ADDENDUM # 2

RFB #: RFB-RC-CP1521-001

Renovation/Construction - Sheriff's Operation Building

DRAWING NO.: E001.00

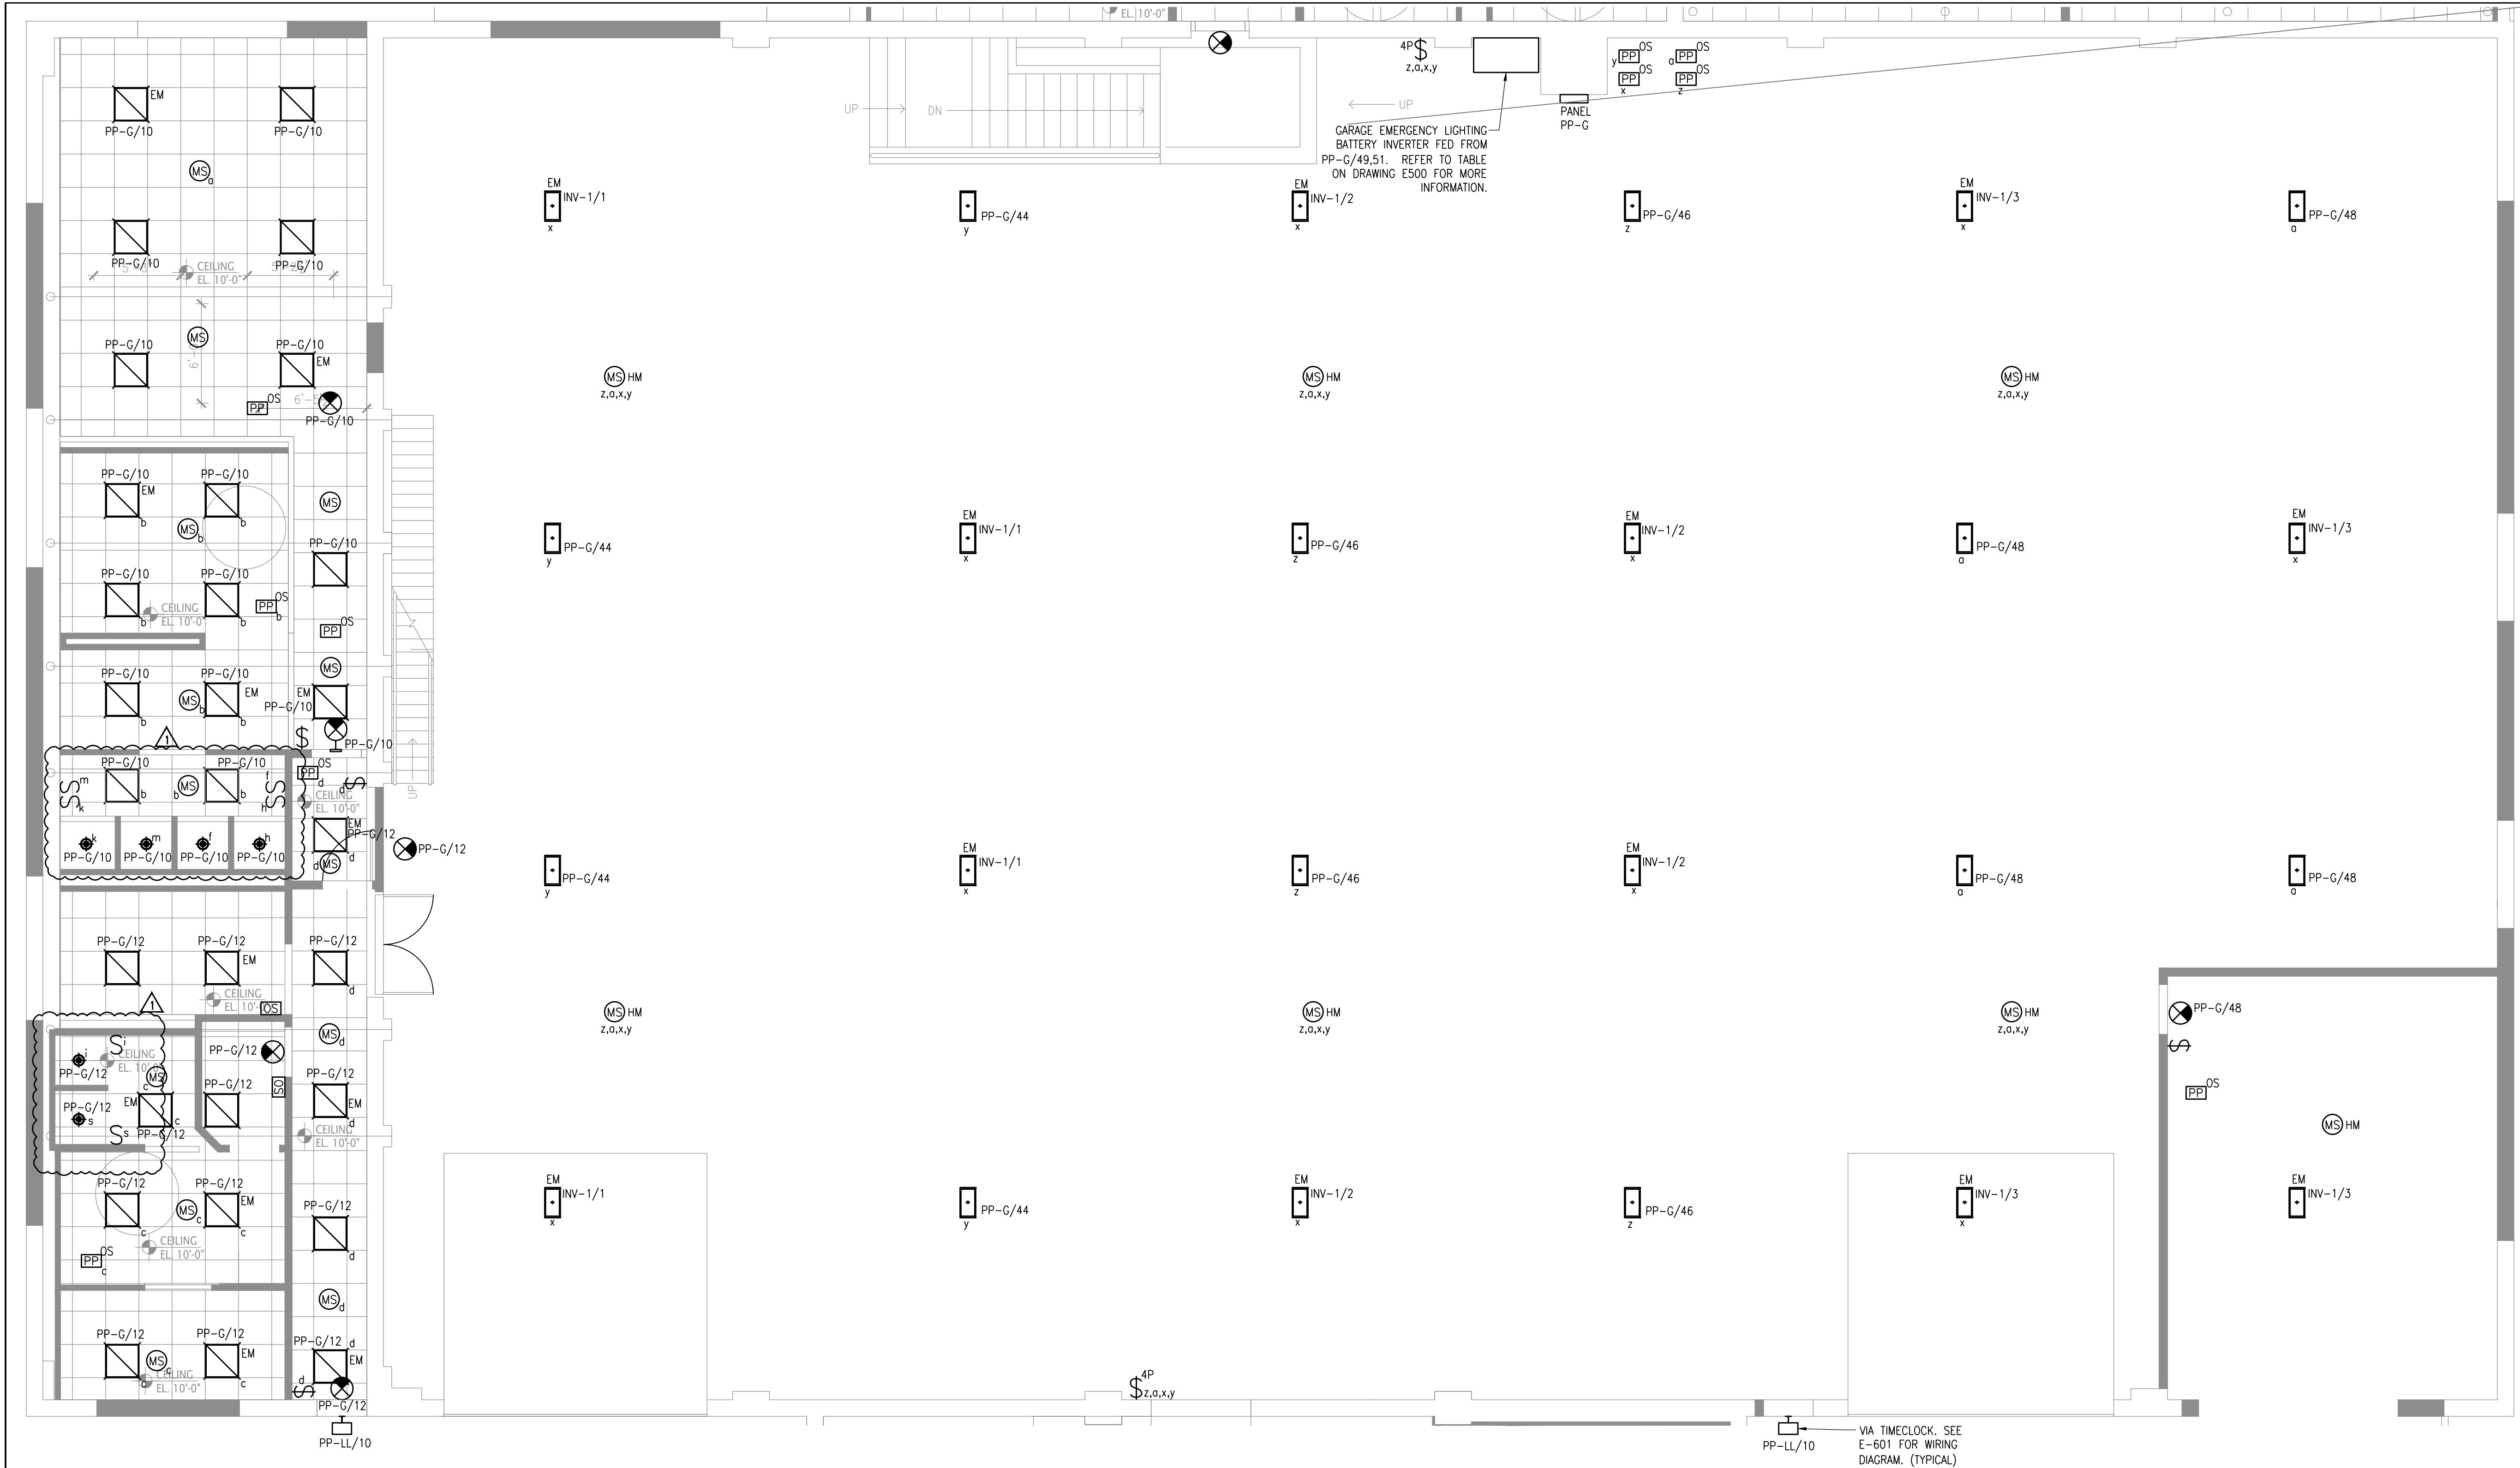
6. Data symbol on E001.00 specs a (6) port wall plate, with (1) white Cat-6, and (5) black Cat-6 Data cables. When referring to Page E-601, the detail calls for a (2) port wall plate with (1) white Cat-6 for data and (1) blue cat 6 for voice. We need to know which is the correct spec.

Response: *The Data symbol on E001.00 specifying: (6) Port Wall Plate with (1) White Cat-6 and (5) Black Cat-6 Data is correct.*
